# Access Compliance Report

## Public Rights-of-Way

Intersection ID: 42786	Main Street: ERWIN_RIDGE_AV	Cross Street: FRANCES_GLEN_DR	Location: W
ADA ID: F369FC52BCED	Ramp Type: PerpDiag	Initial Pass/Fail: Fail	Overall Compliance: No
Severity Score: 47.5			
Codes/Mitigation Info/Possible Solution		Field Measurements/Component Compliance

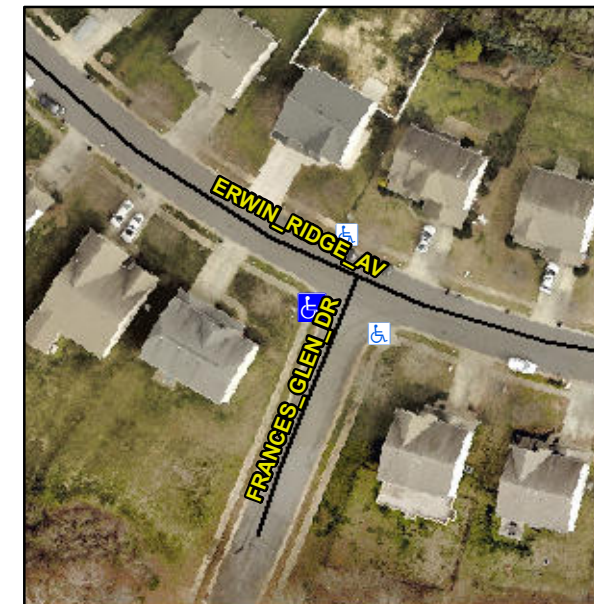
**Not Found, R304.5.1, R304.5.3**

Compliance	Description	Data	Compliance	Description	Data
N/A	Ramp Length (in)	47.0	Yes	Ramp Slope (%)	5.1
No	Ramp Width (in)	30.0	No	Ramp XSlope (%)	5.2
N/A	Flare Type LT	N/A	N/A	Flare Type RT	N/A
N/A	Flare Slope LT (%)	N/A	N/A	Flare Slope RT (%)	N/A
N/A	Flare Traversable LT?	N/A	N/A	Flare Traversable RT?	N/A
N/A	Landing Length (in)	N/A	N/A	DWS Provided?	N/A
N/A	Landing Width (in)	N/A	N/A	DWS Contrast?	N/A
N/A	Landing Slope (%)	N/A	N/A	DWS Length (in)	N/A
N/A	Landing X Slope (%)	N/A	N/A	DWS Full Width?	N/A
N/A	Landing Curb? (Y/N)	N/A	N/A	DWS Offset (in)	N/A
N/A	Shared Landing?	N/A			
N/A	Gutter Ponding?	N/A	N/A	Gutter Slope (%)	N/A
N/A	Gutter Lip Ht (in)	N/A	N/A	Gutter X Slope (%)	N/A
N/A	Painted X Walk1?	No	N/A	Painted X Walk2?	No
	X Walk 1 Direction	To S		X Walk 2 Direction	To E
N/A	X Walk 1 Width (in)	N/A	N/A	X Walk 2 Width (in)	N/A
	X Walk 1 Slope (%)	0.8		X Walk 2 Slope (%)	2.8
	X Walk 1 X Slope (%)	5.3		X Walk 2 X Slope (%)	0.3

**Remove & Replace Curb Ramp With Two New Directional Ramps or Equivalent.**
